21/2021/RES - Approval of the reserved matters of access, appearance, landscaping, layout and scale children's day nursery with associated engineering works, infrastructure, car parking and landscaping

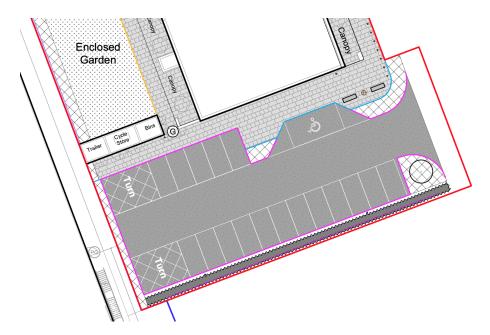
The amount of cycle parking provided is currently insufficient and the space provided is too small. The cycle store included in the plans is covered and secure which is welcome. However the storage shed is less than 4m wide as measured on the plan. It contains 4 sheffield stands, with the inner spacing between stands around 90cm (35") and the outermost stands spaced only 45cm (18") from the side walls of the store. This is well below the Department for Transport's Local Transport Note (LTN) 1/20 standards which state:

11.4.6 Cycle stands require at least 0.6m clearance to walls, and a clear space of 1.0m in front to enable the bicycle to be wheeled into position. A distance of at least 1.0m between stands enables bicycles fitted with panniers or child seats to gain access. Other types of cycle are longer and wider and will require additional space (see Figure 11.3 and Table 11-2).

The current spacings are such that the effective capacity of the store will be only 6 bikes. The nursery is described as having capacity for 100 children, which given advised staff-to-child ratios suggests a staff of around 20. The currently planned cycle parking means that many who might wish to cycle to work will be prevented from doing so by the lack of provision.
